T18SZ SOFTWARE UPDATE CHANGES

V1.5 - V1.8

T18SZ SOFTWARE UPDATE CHANGES

V1.4

◆ Point deletion method

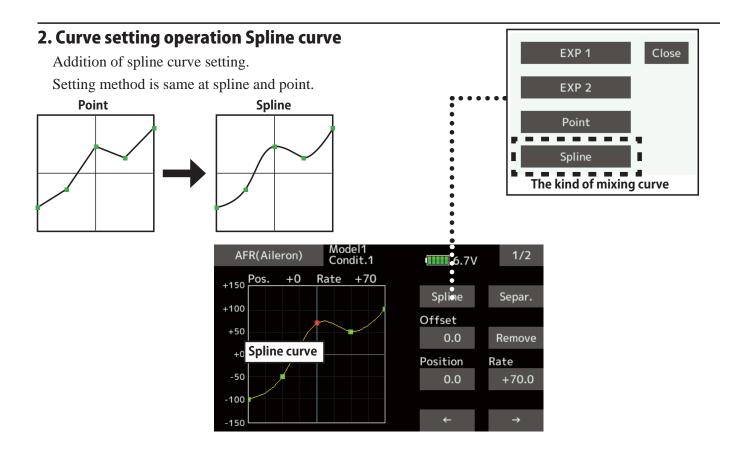
① Use the move between points button [\leftarrow] or [\rightarrow] and select the point. (The red point \blacksquare is the selected point.)

- ② Tap the [Remove] button. (The selected point becomes an outlined point □)
- ③ Use the move between points button [←] or [→].

*The point is deleted.

♦ System menu change

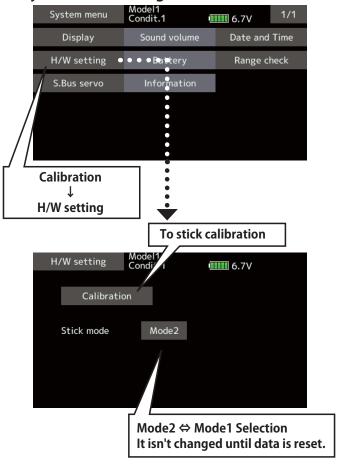
5. Stick mode

Addition of stick mode function.

Mode 2 or Mode 1 can be chosen.

But, it isn't changed until data is reset.

To change the mode the stick ratchet must be changed. Request that this be done by Futaba Service. (Charged modification)
